Public Works Subcommittee

Meeting on 7 January 2009

List of issues requiring follow-up actions by the Administration

Item PWSC (2008-09)55

剖面圖(東面,南面和西面看台) SECTION (East, South & West Stand)

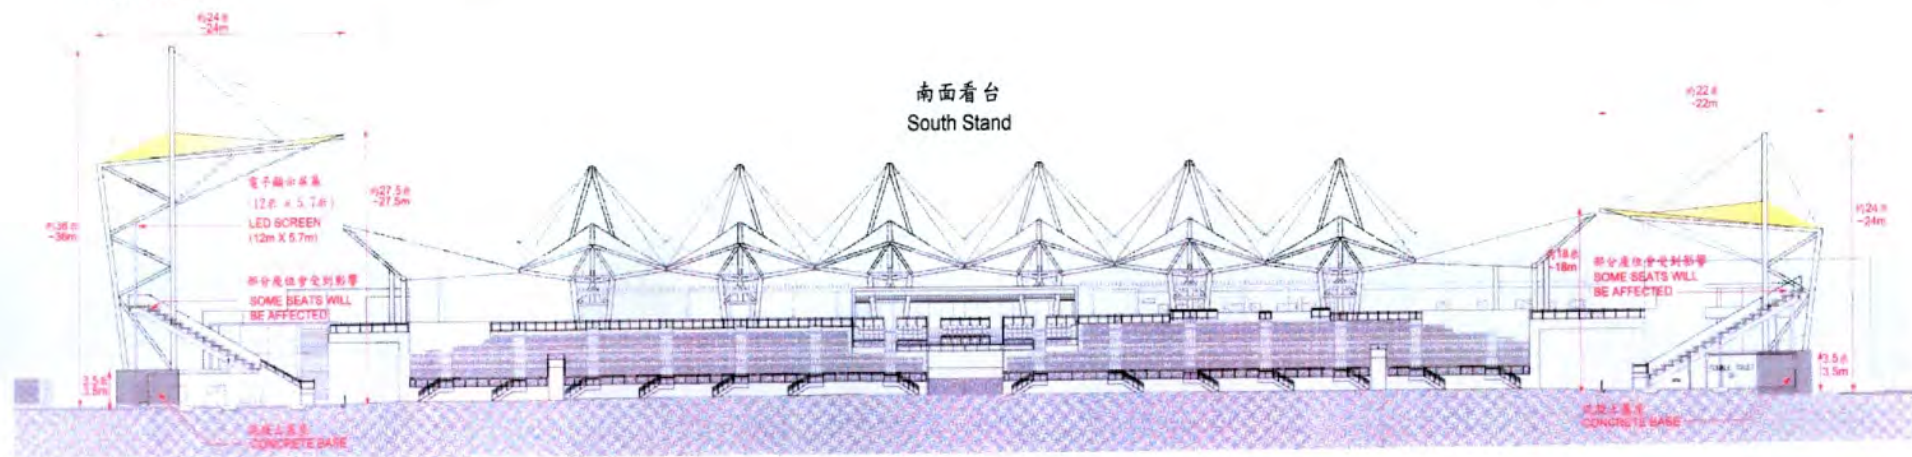
Members requested the Administration to consider providing cover for the spectator stands on the East and West sides, and to consider whether the design of the spectator stands could be adjusted to increase the overall number of seats provided at the Mong Kok Stadium; and to provide a written response on these suggestions including an estimate of any additional costs, where applicable, before the relevant meeting of the Finance Committee (FC), or in due course if a funding proposal on any of the above suggestions would be submitted separately for the consideration of FC.

在東面加設的上蓋須豎設於電子顯示屏幕之上。這做法會令上蓋不能有效地為觀眾遮擋風雨和午間的陽光
Additional cover on the east side will have to be erected above the LED screen which cannot provide shelter for spectators against rain and sunshine in the afternoon effectively

Overall height of the west cover will be higher than the north and south covers. It is not desirable from aesthetic point of view and cause further visual and air circulation concern to the nearby residents
